**Acton Board of Health
Agenda
January 12, 2009
Acton Memorial Library**

TO: Board of Health
FROM: Justin T. Snair
RE: I/A Technology Use Approval
DATE: January 7, 2009

Re: 525-541 Massachusetts Avenue
West Acton Village Project

TO: Board of Health
FROM: Justin T. Snair *JTS*
RE: Alternative Percolation Testing Approval
DATE: December 30, 2008

CONCEPTUAL SEWAGE DISPOSAL PLAN
 ACTON, MASSACHUSETTS
 (MIDDLESEX COUNTY)
 FOR ROSENFELD
 SCALE 1" = 20'
 JANUARY 7, 2009
 STANSKI AND MCNARY, INC.
 80 HARRIS STREET, ACTON, MASSACHUSETTS
 ENGINEERING - PLANNING - SURVEYING

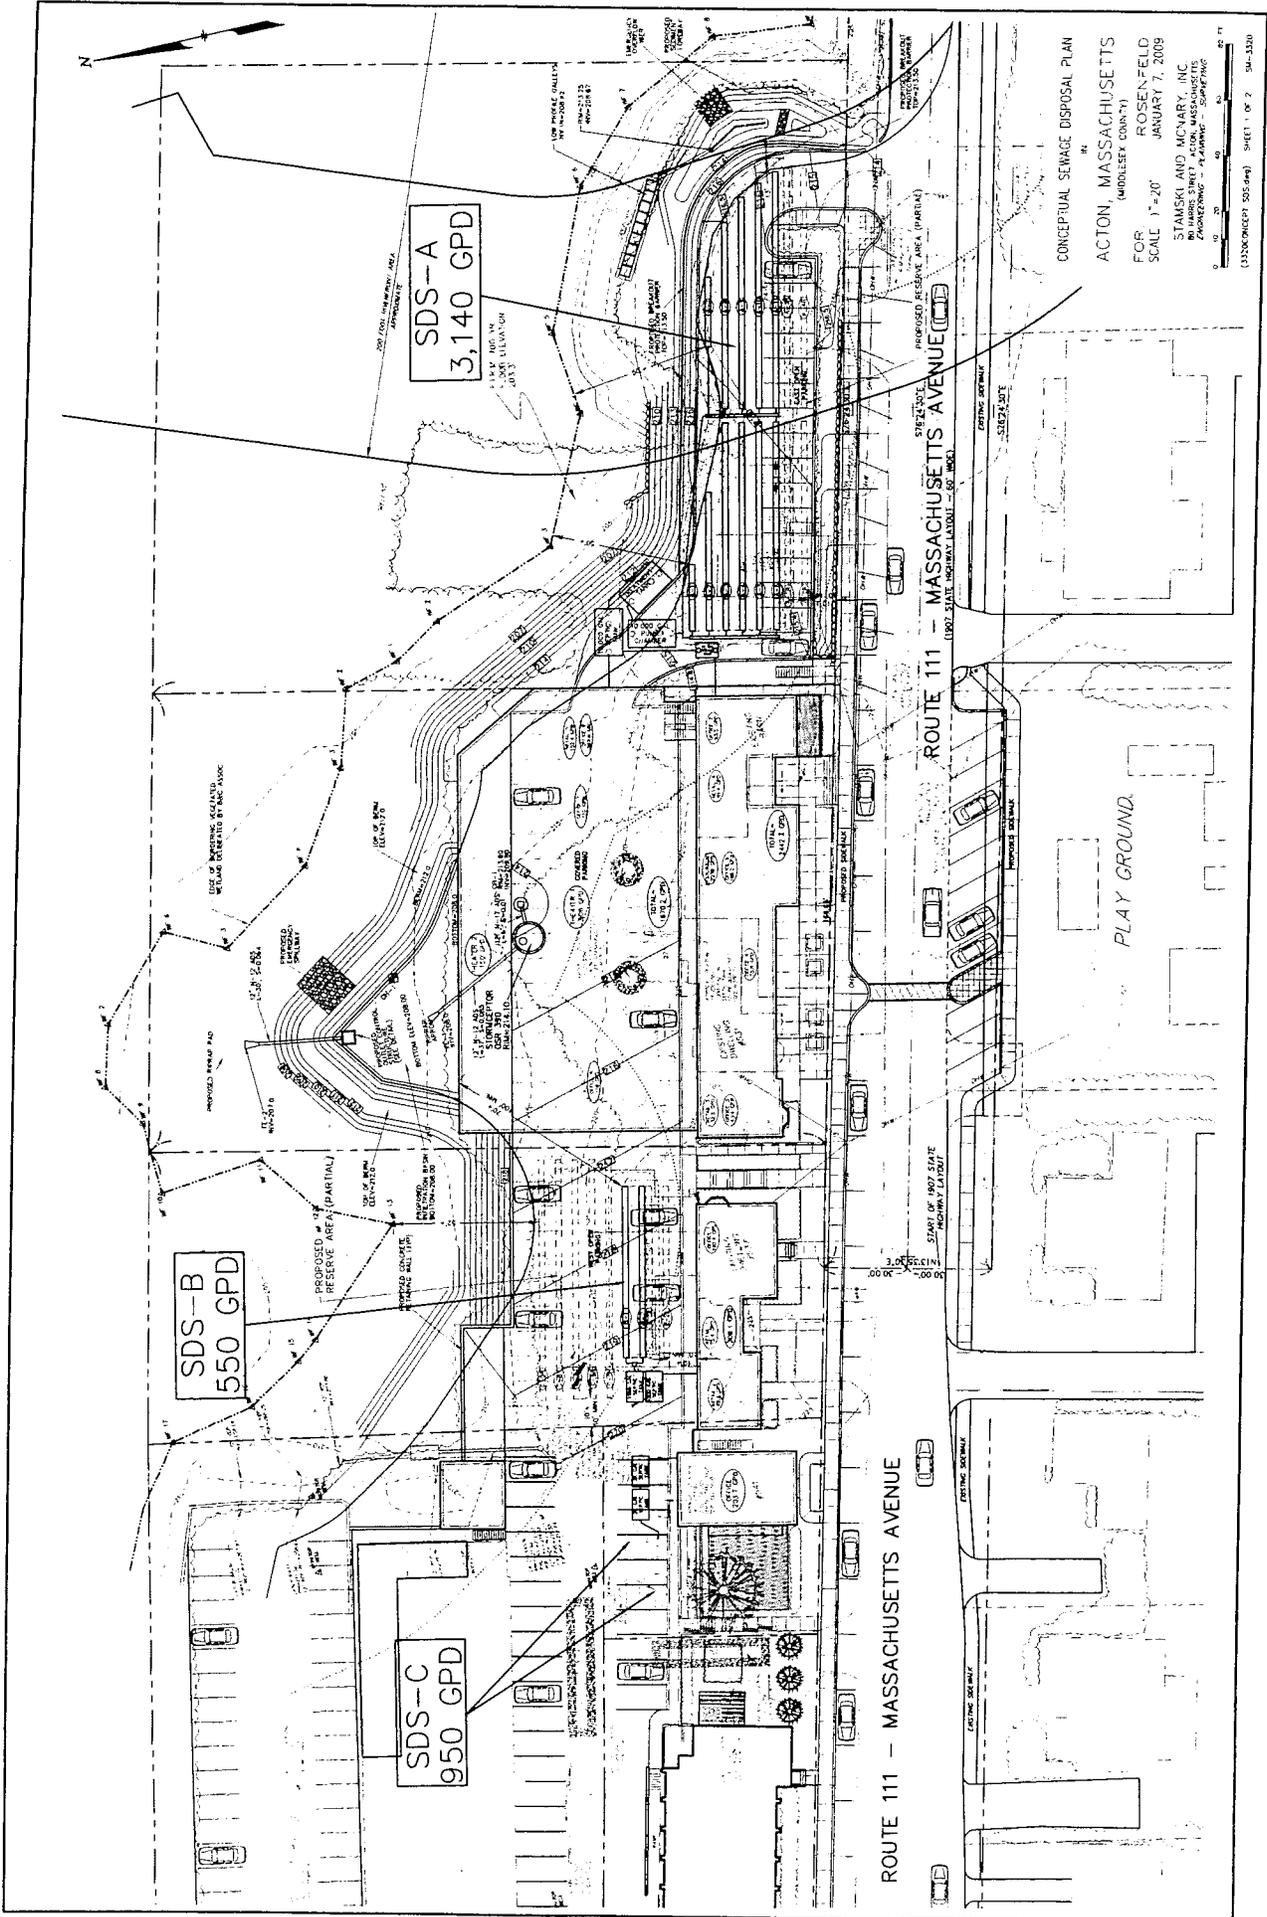
The overall concept requires that the local regulations be waived in as follows:

- **Article 11-6.1.2** No sewage disposal system with a capacity of 2,000 gallons per day or greater shall be constructed within one hundred (100) feet of any wetland (Any land area or surface area so defined by the Massachusetts Wetland Protection Act, MGL Ch. 131, s. 40 and/or the Town of Acton Wetlands Protection Bylaw.)

- The proposed primary and reserve Soil absorption System (SAS) for System A is located more than 50 ft but less than 100 feet from a Bordering Vegetated Wetland.

- A waiver is required to allow the proposed soil absorption system to be located within the 100' buffer zone. The soil absorption system will not have an adverse effect on the wetlands or groundwater because treatment is being provided to reduce the BOD, TSS, and total Nitrogen concentration beyond the Title 5 required levels. An alternative technology will be used to treat effluent to 30 mg/L BOD, 30 mg/L TSS, and 25 mg/L Total Nitrogen.

- **Article 16-4.2.10** All leaching areas within an aquifer zone shall be set back 100' from any recharge, retention, detention or surface drainage area.

- The proposed primary area for SDS-A is located 12 ft from the proposed Rain Garden.
 - The proposed reserve area for SDS-B is located 70 ft from the proposed Infiltration Basin.

- A waiver is required to allow the proposed soil absorption system to be located within 100 ft of the rain garden and infiltration basin. This waiver

would be necessary is due to significant site constraints. The project would meet Title V minimum standards overall and would exceed Title V standards with the proposed alternative technology.

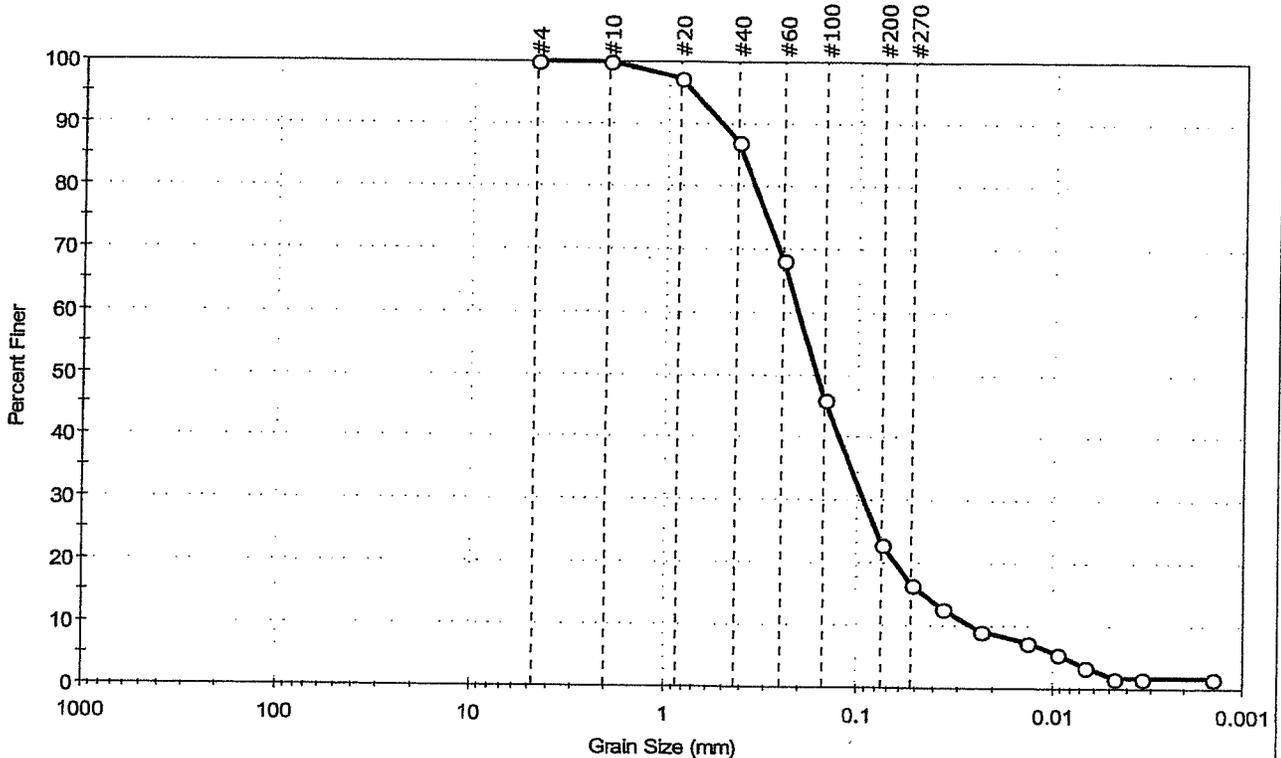
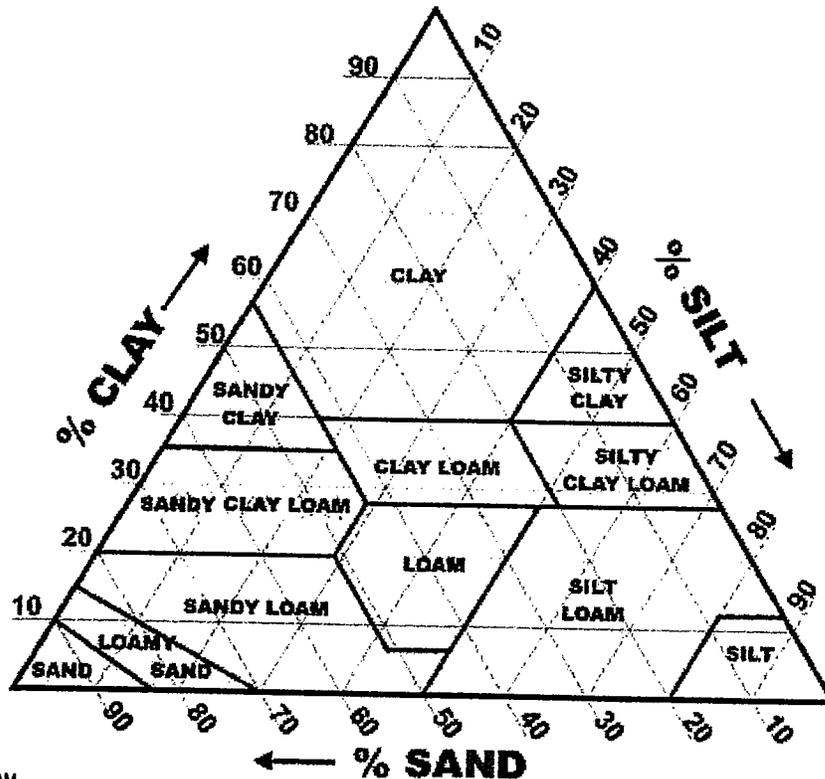
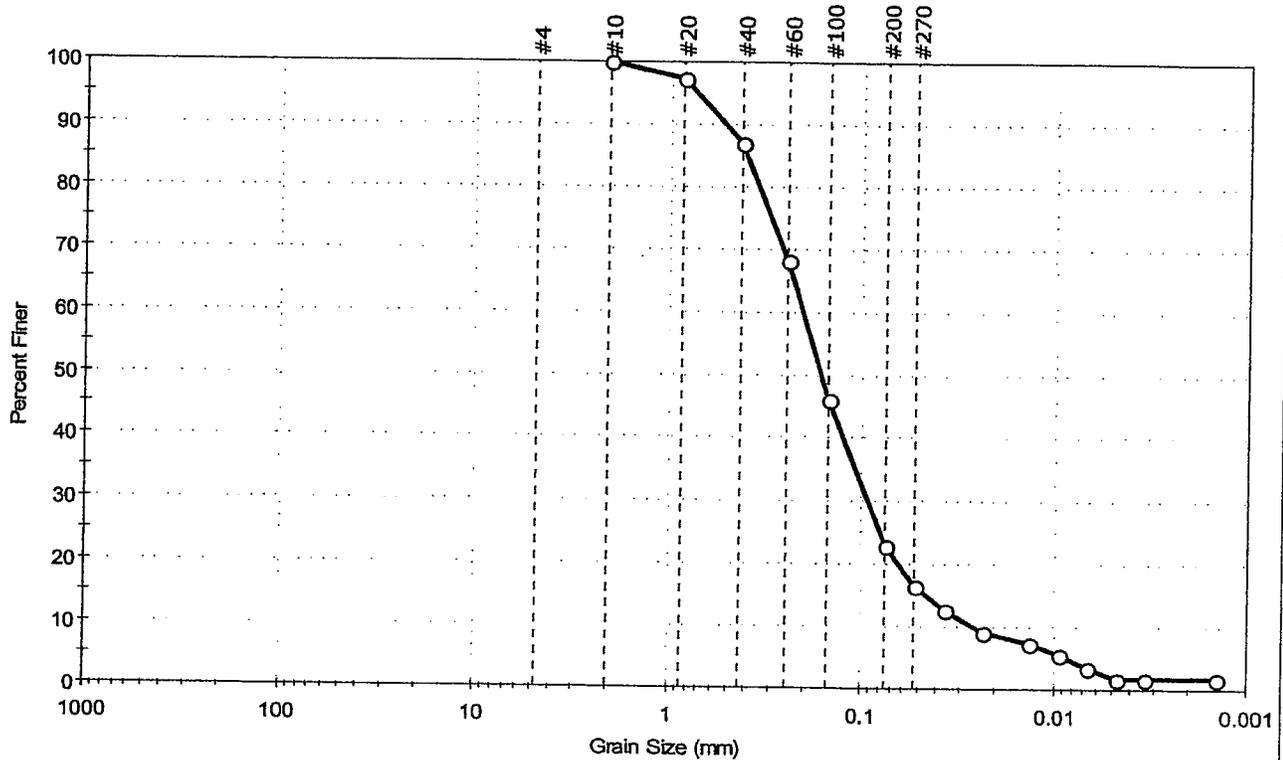
The Health Department finds the submitted results in accordance with MA DEP Policy #: BRP/DWM/PeP-P00-4 (superseding P00-1) and recommend Sample 2 for approval as a percolation test substitute, as it is the most restrictive layer, with the following conditions:
